Hillsborough County Florida

SM STAFF REPORT

SUBJECT:	PRS 20-1310	PLANNING AREA:	Riverview/Balm
REQUEST:	Minor Modification to an Approved PD	SECTOR	South
APPLICANT:	Balm Grove LLC		
Existing Zoning: PD 18-0304		Comp Plan Category: RP-2

Figure 3: Proposed Site Plan

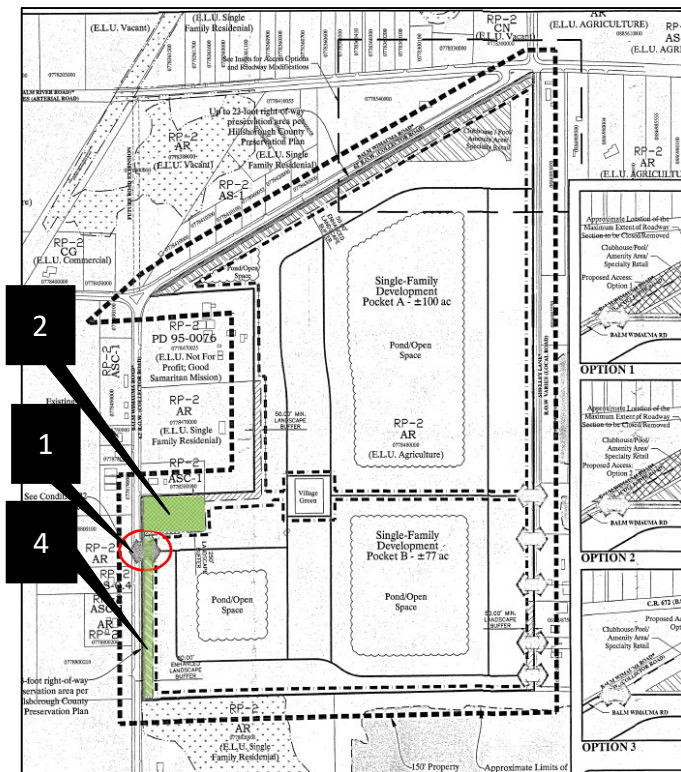
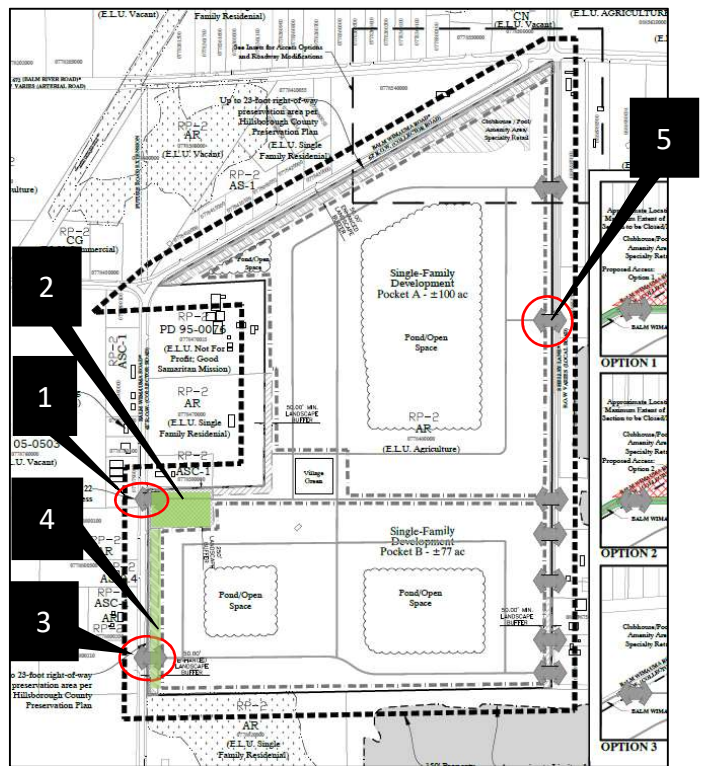
1. Relocate an access point and internal roadway northward along the western boundary, through a previous approved perimeter buffer. The subject access point and internal road in the northwest portion of the site (see #1 in Figure 2) was approved to be located outside of 400 foot wide and 250 foot deep buffer positioned along the southern boundary of folio 77850.0000 (see #2 in Figure 2). Folio 77850.0000 at the time of the rezoning was not owned by the applicant. Since that time, folio 77850.0000 has been purchased by the applicant; however, it is not part of this PD. The new, proposed location (see #1 in Figure 3) is shown to be run horizontally through the buffer (see #2 in Figure 3).

The current moratorium restricts perimeter buffer reductions, unless the reduction is to provide for connectivity to adjacent property or rights-of-way. Staff concurs with the applicant's position that no buffer reduction is occurring due to the additional buffer area proposed. To accommodate the 50 foot wide internal road, the depth of the buffer will be increased to 300 feet, resulting in a 400 foot wide by 300 foot deep buffer (see Figure 4). The subject access point will continue to provide for connectivity to the adjacent right of way. Furthermore, the residential building envelope remains to be located outside of the buffer.

Per the applicant, the relocation of this access point improves the internal circulation and provides an improved alignment with the eastern portion of the roadway which connects to Shelley Lane, allowing for a more direct travel route between the two roadways.

2. Add an additional access point along the western boundary, through a previously approved buffer. The applicant has requested an additional access point to serve the project and Pocket B (see #3 on Figure 3). This new access point will provide direct access to the north/south segment of Balm Wimauma Road for the southern project area (Pocket B). Under the original rezoning, a reduced buffer of 50 feet in width was approved in this area (see #4 on Figures 2 and 3).

The current moratorium restricts perimeter buffer reductions, unless the reduction is to provide for connectivity to adjacent property or rights-of-way. Per the applicant, the additional access point to the adjacent right-of-way further advances the connectivity of the project to adjacent roadways, while also providing more travel options for project residents. The residential building envelope remains to be located at a distance of 50 feet from the PD boundary.

3. Add an additional access point along the eastern boundary. The applicant has requested an additional access point to provide better connectivity and circulation (see #5 in Figure 3) for the project. This proposed access along Shelley Lane will provide an additional access point for the northern PD area (Pocket A). Under the original rezoning, a waiver to the required 250 foot buffer was approved in this location.

Figure 5: Proposed Site Plan

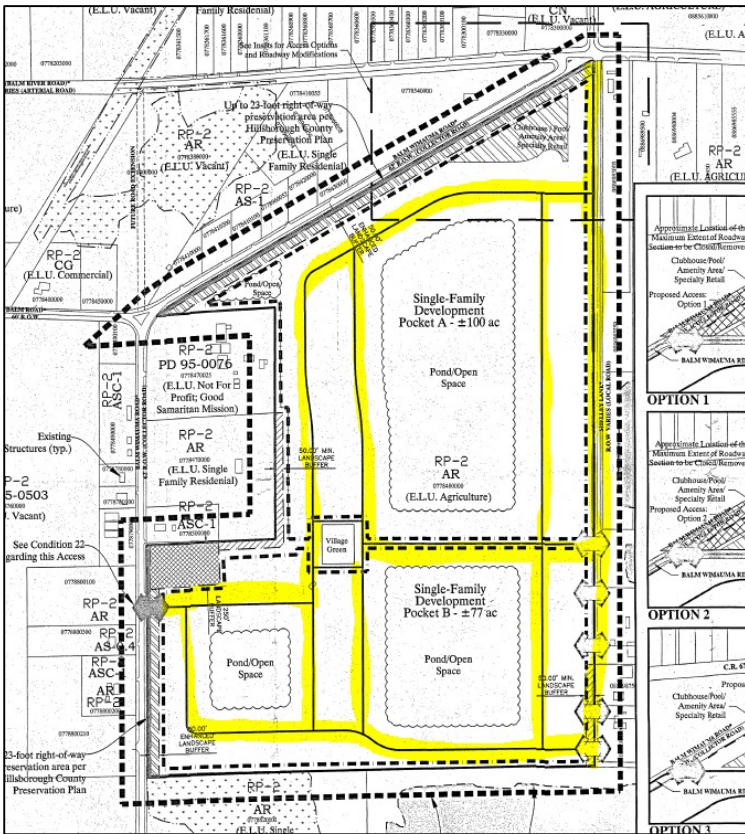
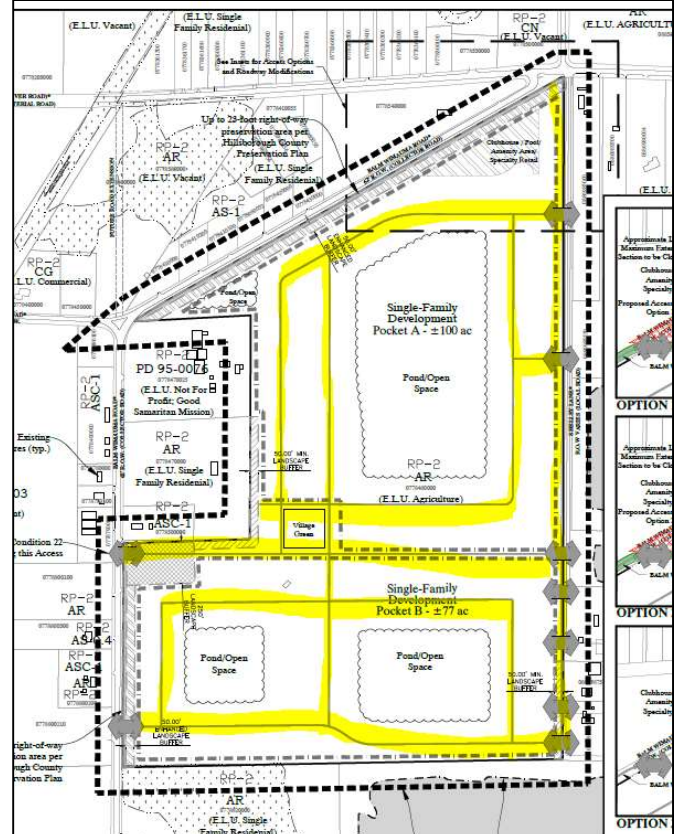
4. Re-configure the internal road network. The project's internal circulation network is proposed to be revised from the 2018 layout (see Figures 4 and 5). The original road network serves Pockets A and B with access points along the west (Balm Wimauma Road) and east (Shelley Lane). Internal connection between Pockets A and B are available via three north/south internal roadways, Balm Wimauma Road and Shelley Lane (see Figure 4). Under the revised layout, one north/south internal roadway will extend to Pocket B to serve as an internal connection between the two areas (see Figure 5). Perimeter access opportunities remain. Pocket B will continue to be situated around two pond/open space areas.

Figure 6: Approved Perimeter Buffer Waivers

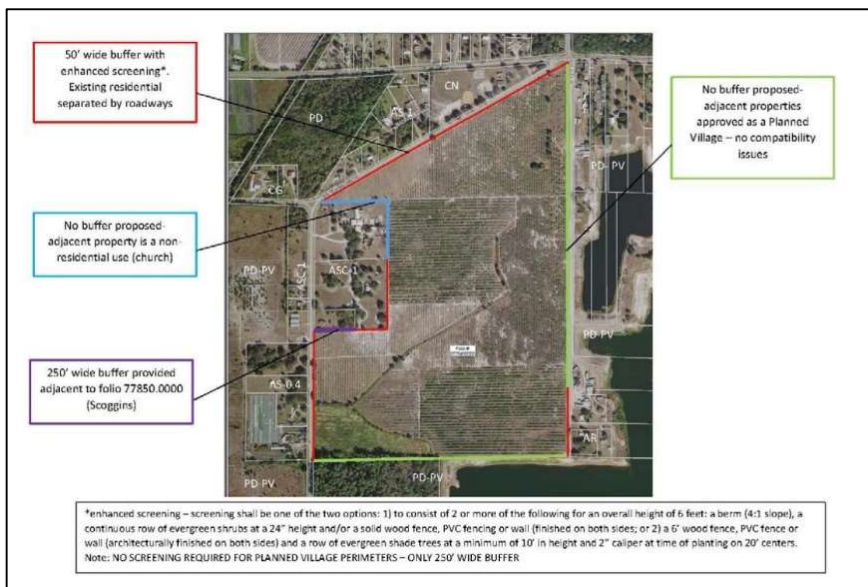
No PD variations are proposed under this minor modification. Under PD 18-0304, the Balm Grove area was approved with a reduction to the 250 foot perimeter buffer around 70% of the site requirement (see Figure 6).

Exhibit 4: Proposed Site Plan

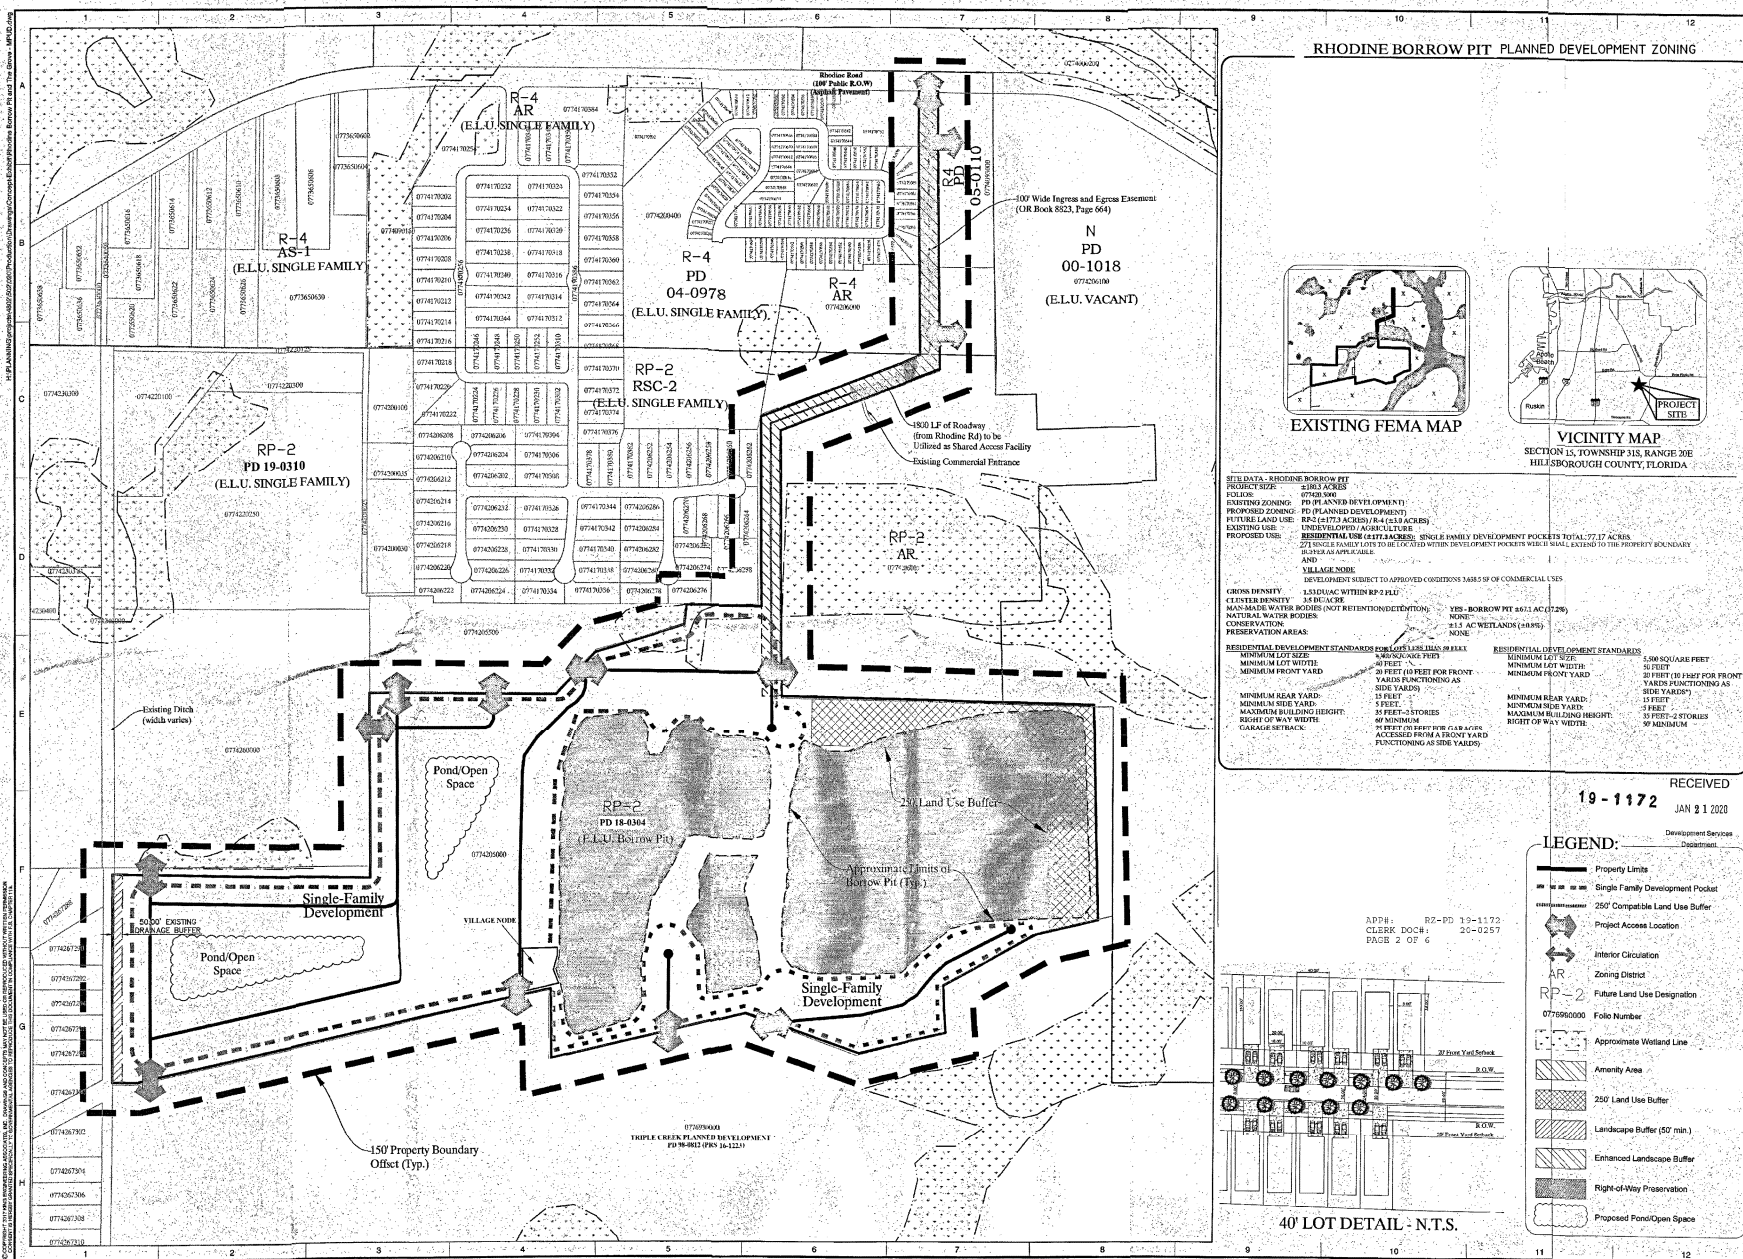
1. All plan sheets to be submitted for certification.
2. On “The Grove” sheet, reference to Condition #22 on the plan for the northern western access point to be corrected to Condition #27.
3. The northwest buffer depth to be corrected to 300 feet.

Modified Access Connection

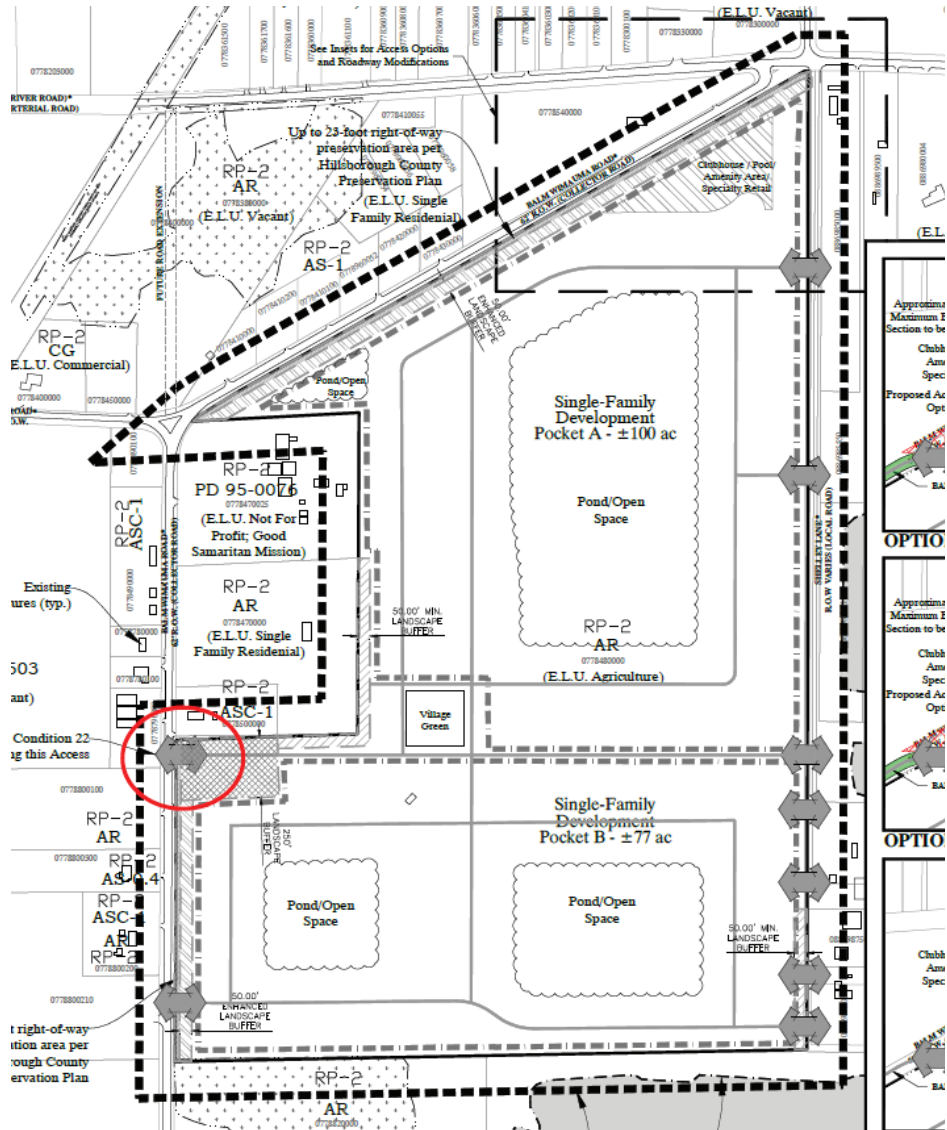
The applicant is proposing to shift the second most southern driveway connection to the north of its previous location (as indicated by the red circle in the image shown at right). The applicant indicates that they have acquired the property to the north of this access (folio 077850.0000) which now provides them additional flexibility with respect to this access. It should be noted that the adjacent folio is not included within the subject PD. As such, staff cannot place a condition requiring its closure with the subject PD. Staff is not objecting to this change, given the condition requiring the access be located a minimum of 330 feet from other access points is still in effect (previously condition number 22, now renumber to condition 27 as further explained above). This condition will ensure that access standards are met as detailed in the condition or the access otherwise relocated.
